ACTION TRANSMITTAL No. 2019-37

SUBJECT: Scope Change Request for Scott County's CSAH 2 and CSAH 91 Roundabout

RE: Scope Change Request
S.P. 070-602-022
CSAH 2 at CSAH 91 Roundabout Improvement
Elko New Market, Scott County, Minnesota

**CSAH 2 - CSAH 91 ROUNDABOUT
PROJECT LIMITS**

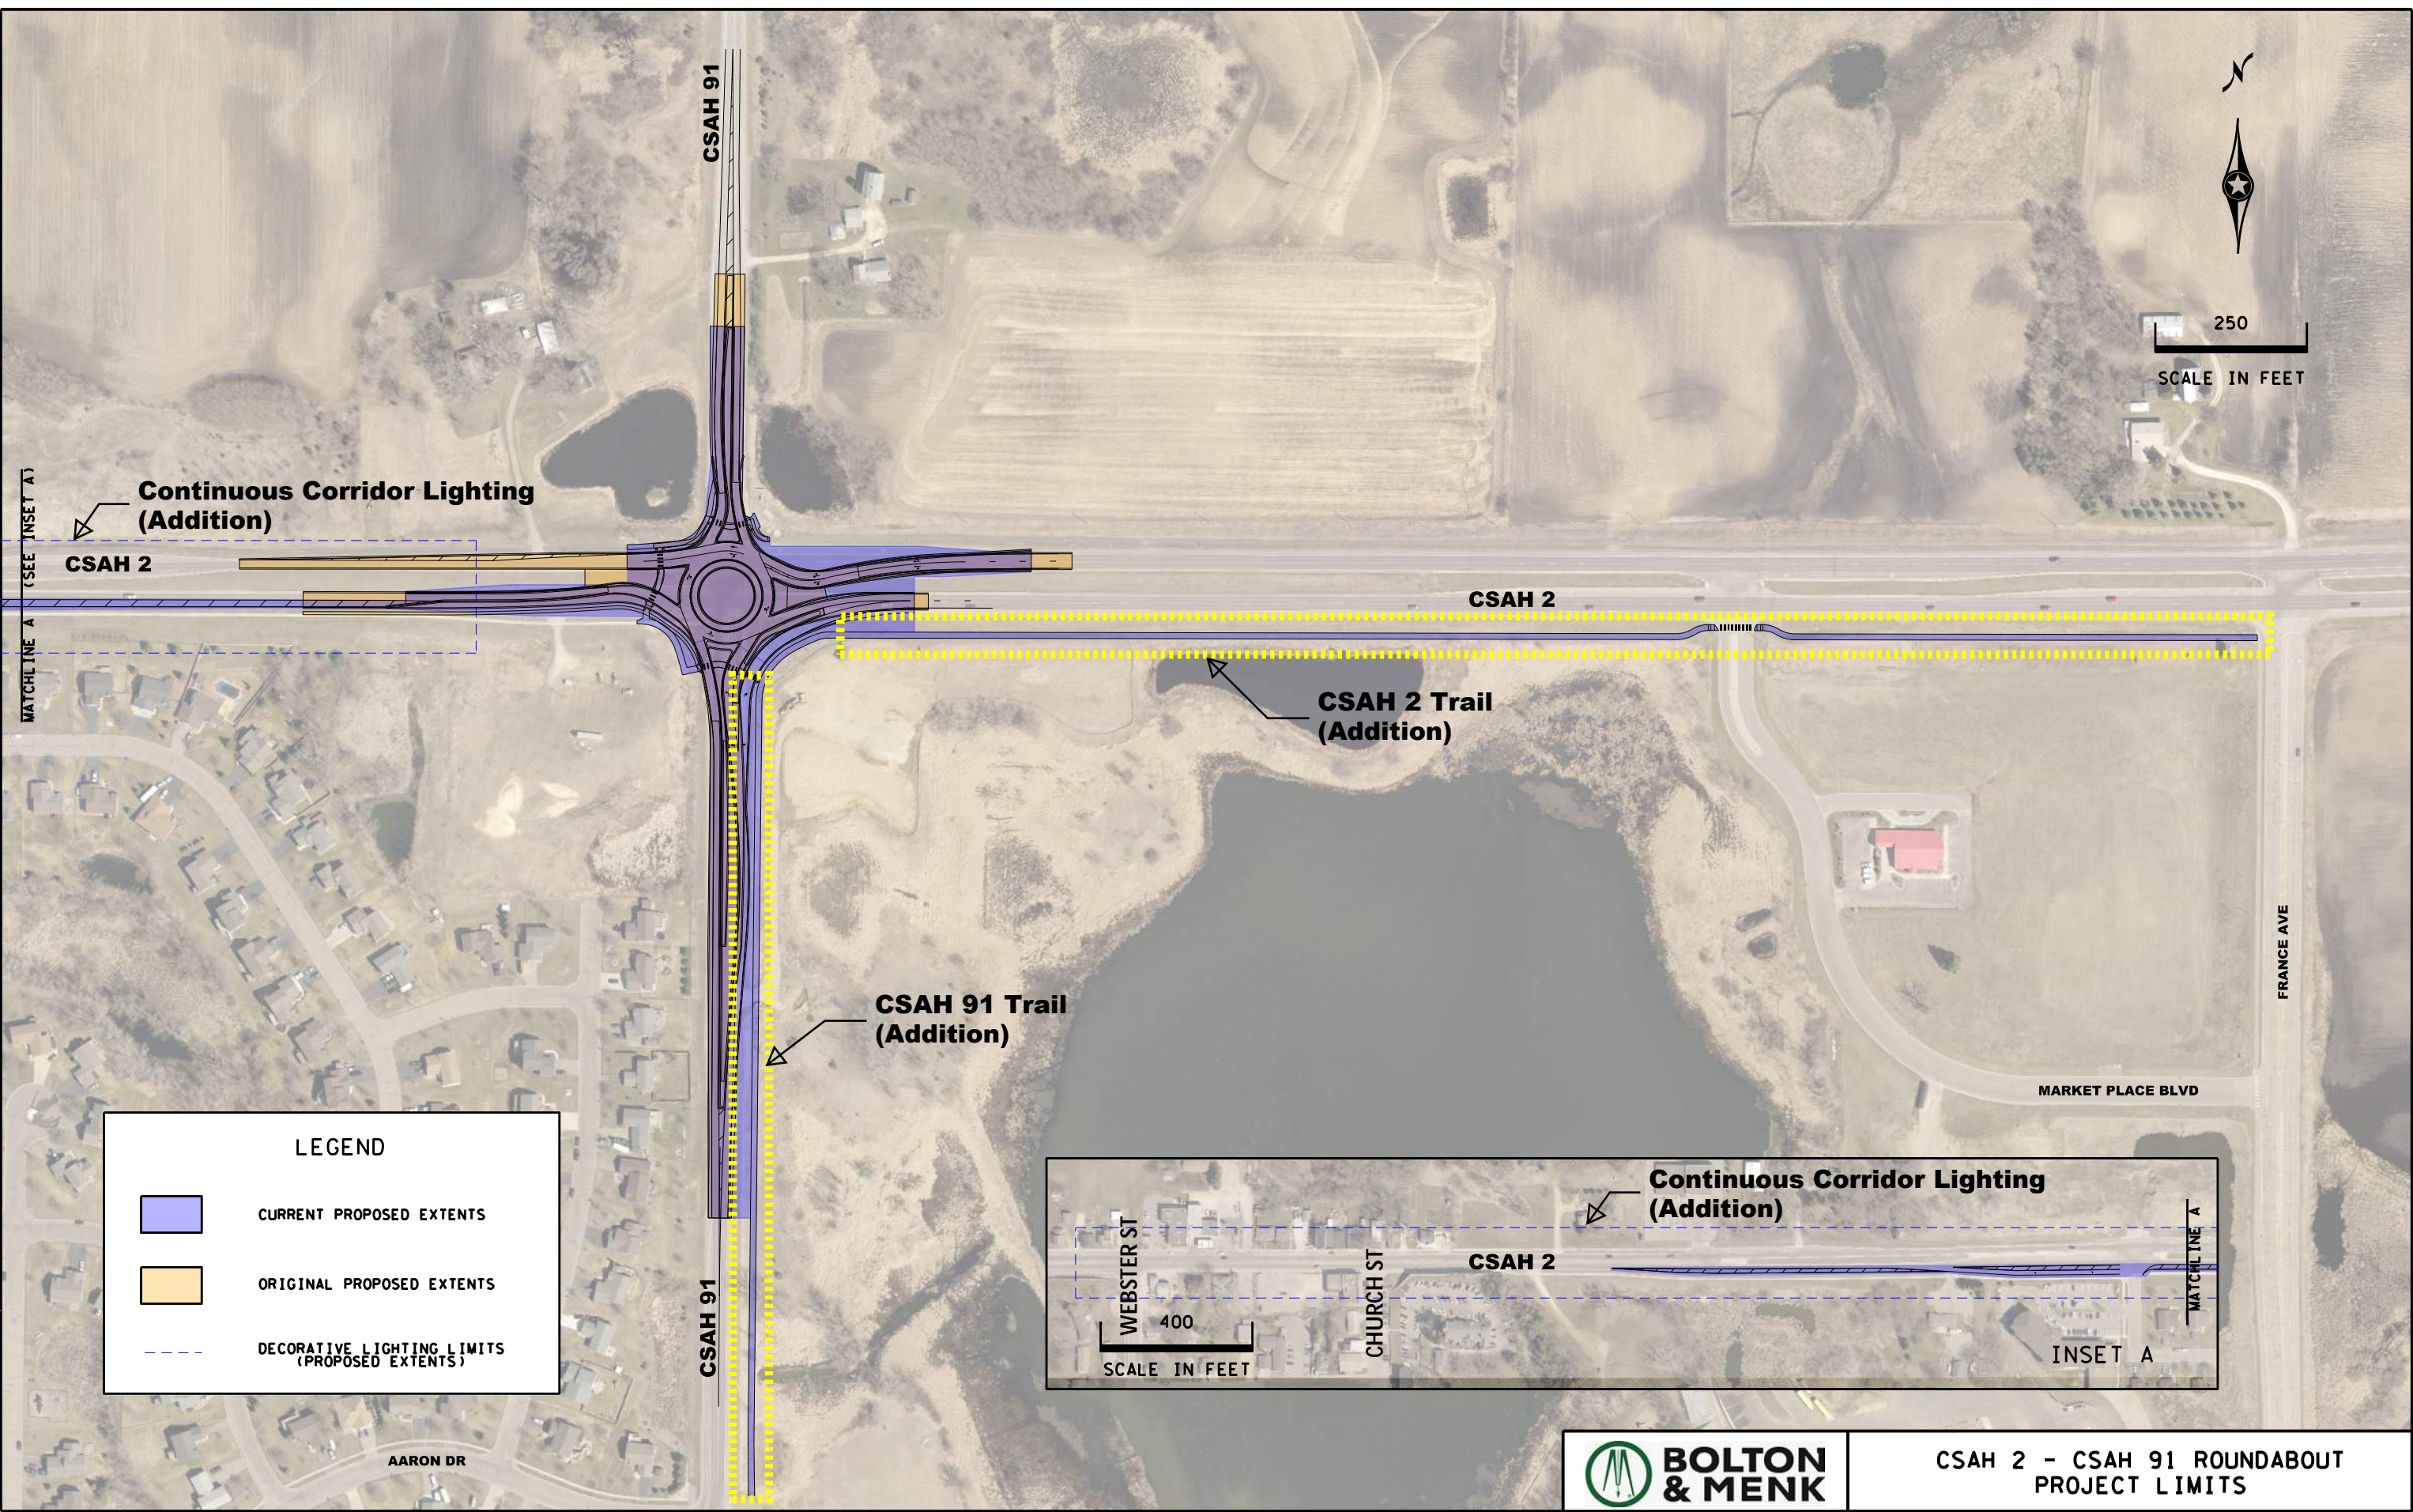
The proposed scope change would include slight modifications to the existing unbalanced roundabout to better accommodate existing and future traffic patterns. In addition to pedestrian facilities proposed in the original concept, additional trail connections are proposed along the east side of CSAH 91 between Aaron Drive and CSAH 2 and along the south side of CSAH 2 between CSAH 91 and France Avenue. Continuous corridor lighting is also proposed between Downtown Elko New Market and the CSAH 2/91 intersection.

- *Roundabout Geometry* – The geometry of the proposed roundabout would be revised from that included in the original proposal to better accommodate existing and future traffic volumes and patterns. An exclusive northbound to eastbound channelized free-right turn lane would be included to more safety and efficiently serve the heavy northbound right-turn movement. The proposed design will also include flexibility to expand from the existing unbalanced (2x1) roundabout to a full multi-lane if future traffic dictates. The proposed improvements also lessen pedestrian crossing distances of the west and south legs of the intersection.

- *Approach Geometry* – The eastbound outside lane of CSAH 2 will be restriped from CSAH 91 to a point approximately 2,200 feet west of the intersection. It is no longer needed with the change in geometrics at the roundabout, which now only requires a single lane of entry for the eastbound approach. This modification was approved by the City of Elko New Market and Scott County.

- *CSAH 91 Trail* – Off-street pedestrian facilities are currently provided along CSAH 91 from Glenborough Drive and Aaron Drive but a gap in the network exists between Aaron Drive and CSAH 2. By fulfilling this segment, a continuous trail network would be provided to between the residents of this area and downtown Elko New Market. The proposed connection extends the project from the original southern termini approximately 1,000 south of CSAH 2 to Aaron Drive (~1/4-mile south of CSAH 2).

- *CSAH 2 Trail* – Off-street pedestrian facilities are currently provided along CSAH 2 from downtown Elko New Market to CSAH 91. It picks up again to the east with a north-south connection along France Avenue (CSAH 33) that serves Elko Speedway, Old Elko City Hall Park, and several residential neighborhoods. The CSAH 2 trail proposed with this project links these two existing trail facilities and provides a complete trail network between downtown Elko New Market, CSAH 91-south, and France Avenue. This extends the project from the original roadway tie-down point ~550 feet east of CSAH 91 to France Avenue (~1/2-mile east of CSAH 91).

- *Decorative Lighting* – Decorative lighting would be added along the south side of CSAH 2 from CSAH 91 to Downtown Elko New Market, west of the CSAH 2/91 intersection. Downtown lighting may also be included with the project. It is understood that all lighting improvements beyond that required for the roundabout are non-participating items.
